## 8A Miscellaneous Electrical Systems

The information in this appendix of the reference ABWR DCD, including all Subsections and figures, is incorporated by reference with the following departures and supplements.

Figure 8A-1 Site Plan (Grounding)

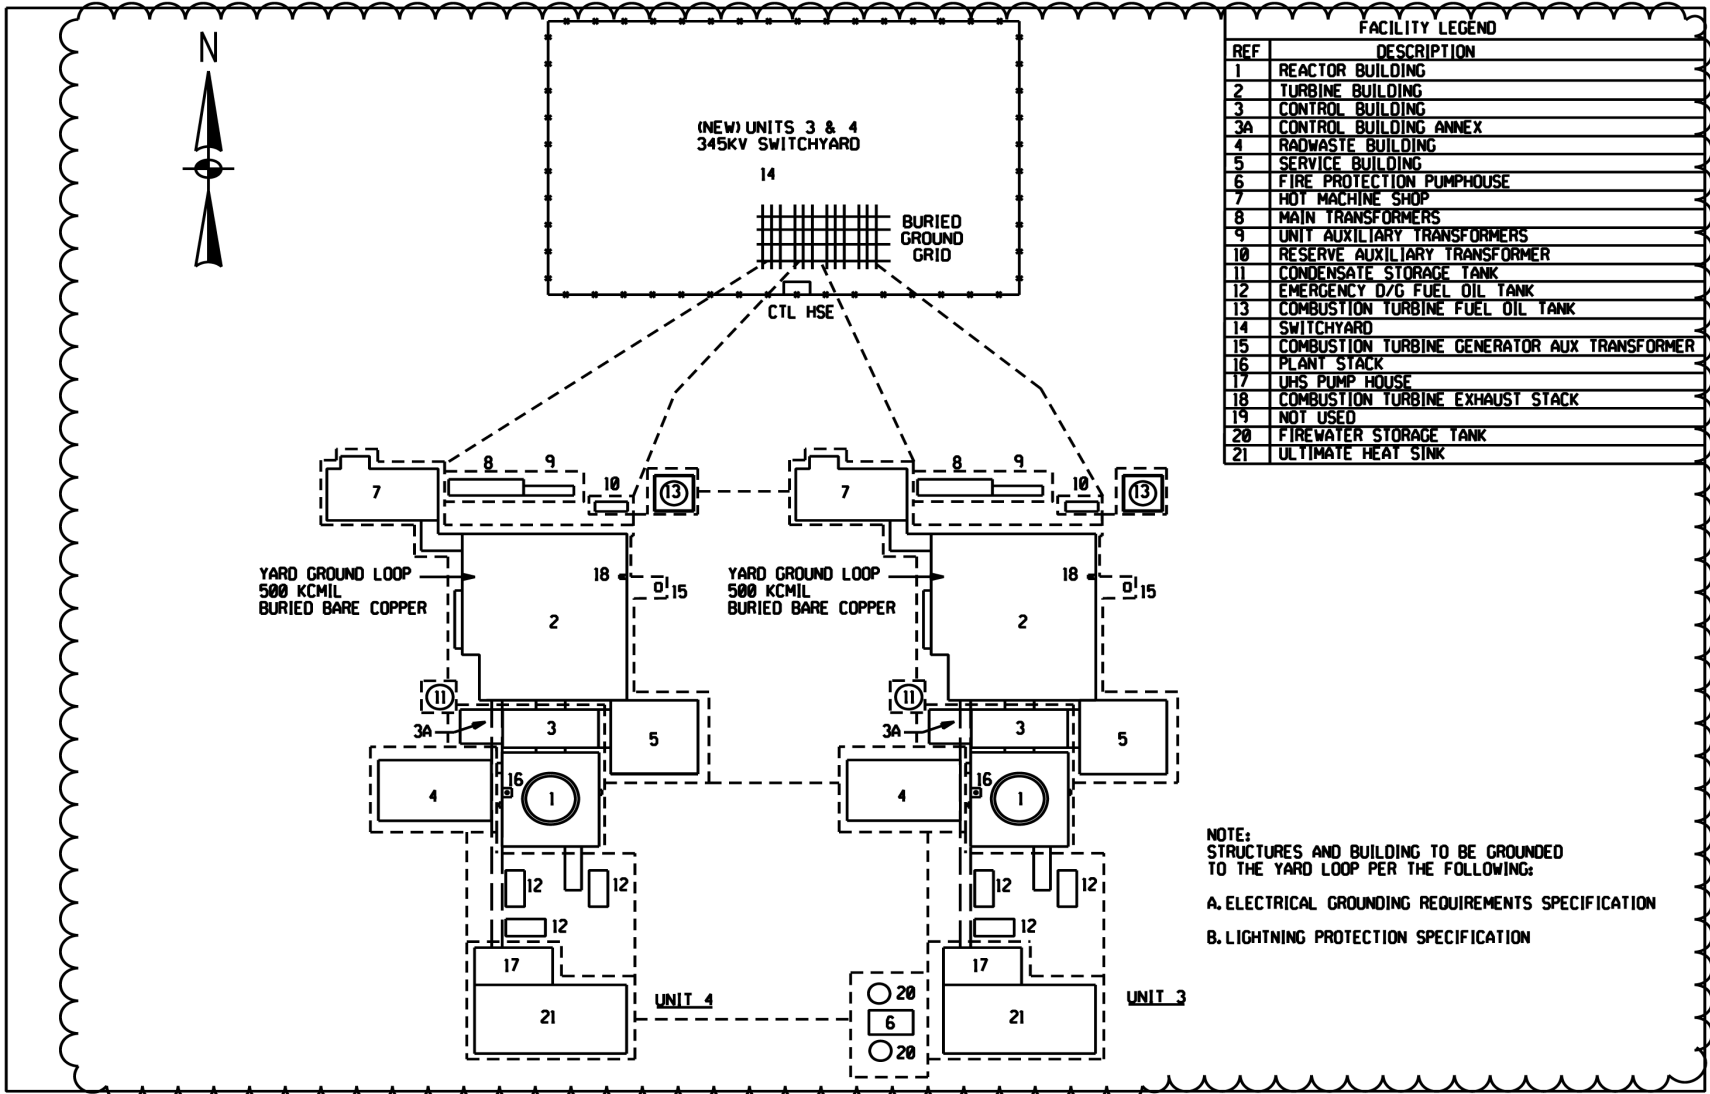
STP DEP 1.1-2 (Figure 8A-1)

STP DEP 1.1-2

- (3) A plant grounding grid shared between STP Units 3 & 4
